# Mumblin Wind Farm

Appendix J – Aviation Impact and Lighting Risk Assessment Review

### Re: Review and Update of Mumblin Wind Farm report

Figure 1 Warrnambool 25 MSA Diagram.

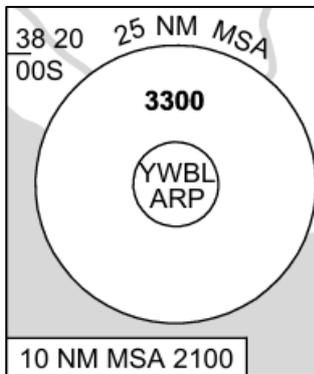
The 25 nm MSA published for Warrnambool Airport (effective 7 September 2023) above the wind farm is 3300 ft AMSL and has a PANS-OPS buffer of 1000 ft below that of 2300 ft AHD.

As the highest WTG will have an elevation of 1258.96 ft AHD, it will not infringe the PANS-OPS surfaces. It will be more than 1000 ft / 300m below the lowest altitude that an FR aircraft can be when overhead the wind farm and using the 25 nm MSA.

The Mumblin Wind Farm will not have any impact upon any PANS-OPS area or surface. (See Figure 1.)

At a maximum height of 1258.96 ft AMSL, the Mumblin wind farm remains below the PANS-OPS surface for the relevant 25 nm MSA sector.

The updated Mumblin Wind Farm will not affect the PANS-OPS surfaces at Warrnambool Airport.
